Item ID: D206-667-103TRN

Item Name: Crosstube Turning DetailL

DART AEROSPACE LTD	Work Order:	96978
Description: Crosstube Assembly (206L High Fwd)	Part Number:	D206-667-143
Inspection Dwg: D206-667-143 Rev: C		Page 1 of 2

DRAWING NO. D206-667-143	TITLE CROSSTUBE ASS'Y (206L HIGH FWD)	REV. C	DART AEROSPACE LTD ENGINEERING ORDER		D.E.O. NO. D206-667-143-C-1	SHEET NO. SHEET 1 OF 1	SCALE NTS
DRAWN 9P	CHECKED ASS	MFG. APPR. [Signature]	APPROVED MD		DE APPR. [Signature]		
DATE 11.07.15	DATE 11.07.20	DATE 11.07.21	DATE 11/07/21		DATE 11.07.21

DETAIL P
BONDING STRAP INSTALLATION 2 PL

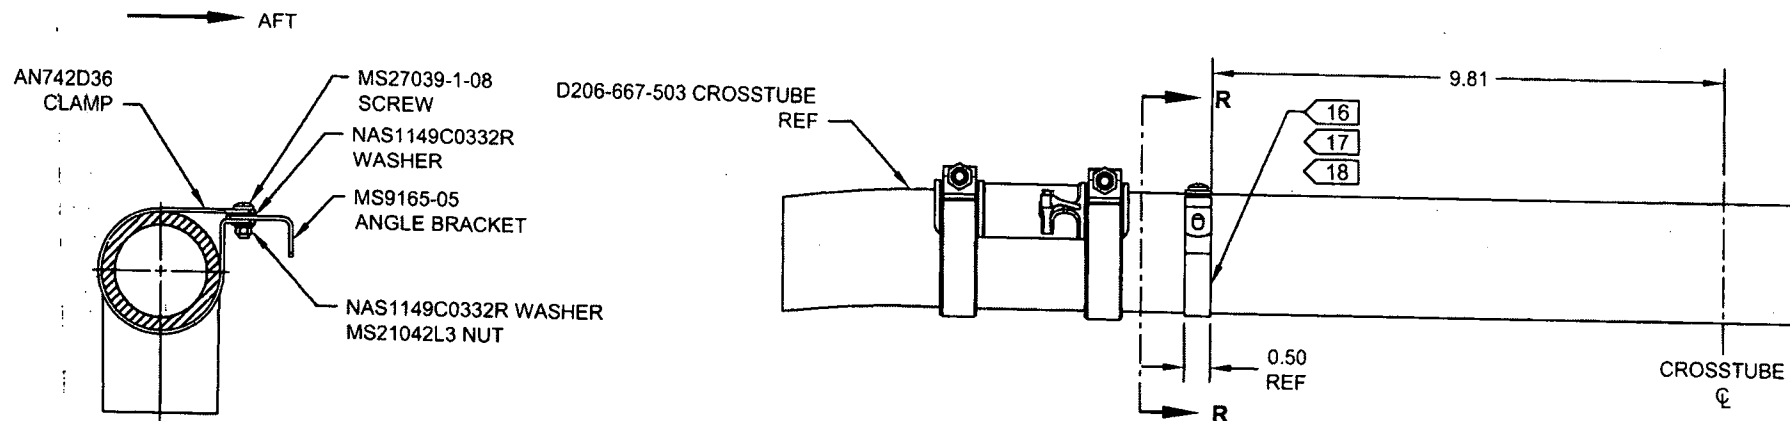
PURPOSE:

ADD ELECTRICAL GROUNDING STRAP

PARTS LIST:

ITEM	QTY	PART NUMBER	DESCRIPTION
1	X	D206-667-143	CROSSTUBE ASSEMBLY (206L HIGH FWD)
⚡			
10	2	AN742D36	CLAMP
11	2	MS9165-05	ANGLE BRACKET
12	2	MS21042L3	NUT (OR MS21042-3)
13	2	MS27039-1-08	SCREW
14	4	NAS1149C0332R	WASHER (OR AN960C10L)

ADD

GENERAL NOTES:

- 16) MASK AREA UNDER CLAMP PRIOR TO PAINTING
- 17) SEAL EDGES WHERE AN742D36 CLAMP MEETS WITH THE CROSSTUBE USING SIKAFLEX-241/-291 OR MIL-S-8802 CLASS B2 OR PROSEAL 890 SEALANT
- 18) PERFORM RESISTANCE CHECK TO ENSURE MAX RESISTANCE IS 10 MILLIOHMS
